## Landscape Referral Response

<b>Application Number:</b>	Mod2025/0018
<b>Date:</b>	28/05/2025
<b>Proposed Development:</b>	Modification of Development Consent DA2023/1869 granted for Demolition works and construction of a Residential Flat Building including the consolidation of 3 lots into 1 lot
<b>Responsible Officer:</b>	Phil Lane
<b>Land to be developed (Address):</b>	Lot 5B DP 158658 , 58 Beaconsfield Street NEWPORT NSW 2106 Lot 6 DP 1096088 , 56 Beaconsfield Street NEWPORT NSW 2106 Lot 7B DP 162021 , 54 Beaconsfield Street NEWPORT NSW 2106

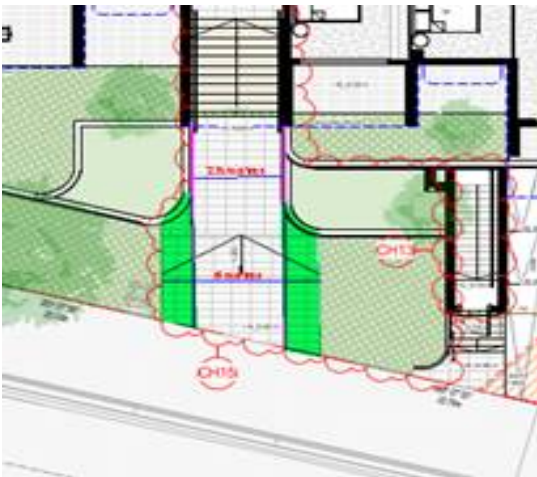
The location of the OSD under the western entrance footpath within the property raises no concerns. However, the width of the eastern entrance footpath at approximately 5 metres in width is not supported as this is not necessary to provide for access activities and the percentage of hardstand within the front setback diminishes the landscape area to an extent that impacts the presentation of the landscape setting as more prominent than the built form as required under Pittwater DCP.

It is suggested that the width of the eastern entrance footpath shall be aligned with the building entry and external walling width as illustrated below. Amended Landscape Plans shall indicate mass planting to the landscape areas either side of the footpath to enhance the entry setting.
